GRIFFEY ENGINEERING, INC.

Watermark Phase 1 & Master Grading Plans

Engineering Review Comments

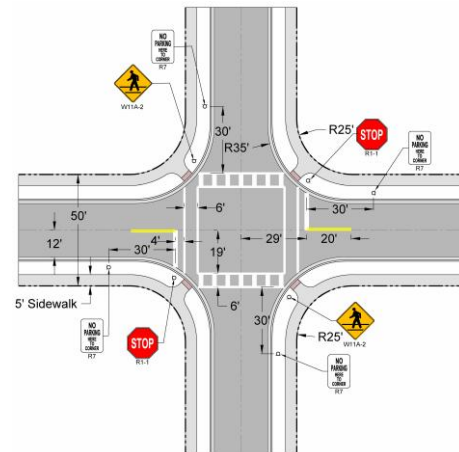
14. Adjust the WM configuration at the SR 19/Revels intersection as shown in the attached exhibit.
